Re: Design Exception #DE18-05 - Curve Radii - 3077 D 1/2 Road

### **DESIGN EXCEPTION #DE 18-05**

### T.E.D.S. EXCEPTION PROPOSAL PEAR PARK PLACE 3077 D.5 ROAD Monday, May 23, 2005

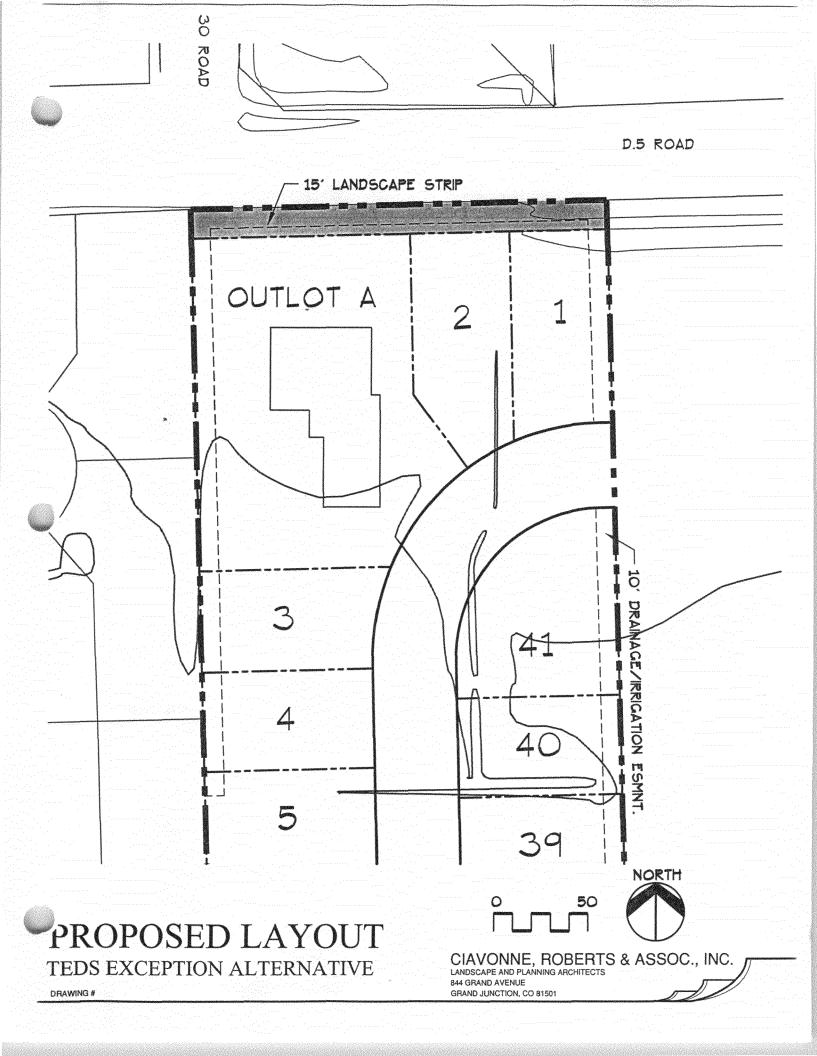
•The site is only 219' wide which would demand an awkward jog in the road leading up to the curve in order to meet the adjacent parcel at a 90 degree angle (if the 150' radius is imposed). See "Alternate 'C'".

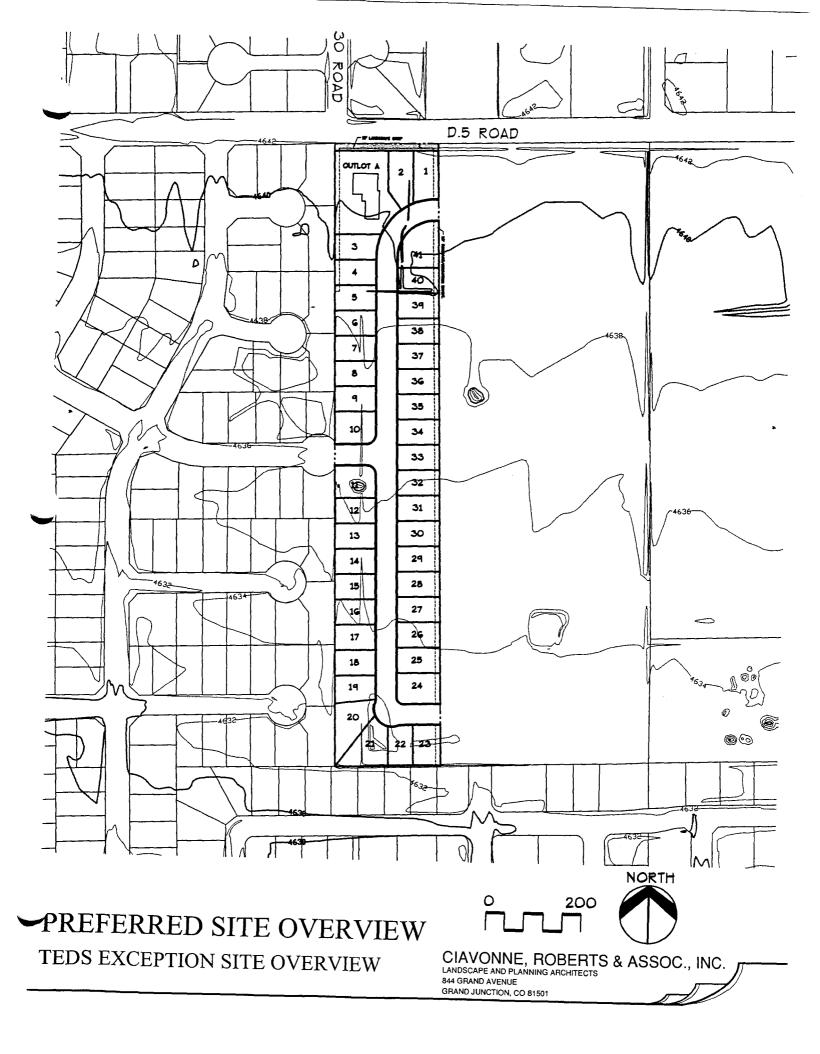
•A through road accessing D.5 Road would replace the curve in question with a 'Tee' intersection which stubs out to the adjacent property, but the intersection at D.5 Road conflicts with intersection proximity regulations and the Pear Park Plan which intends to reduce the number of access points on D.5 Road. See "Alternate 'B'".
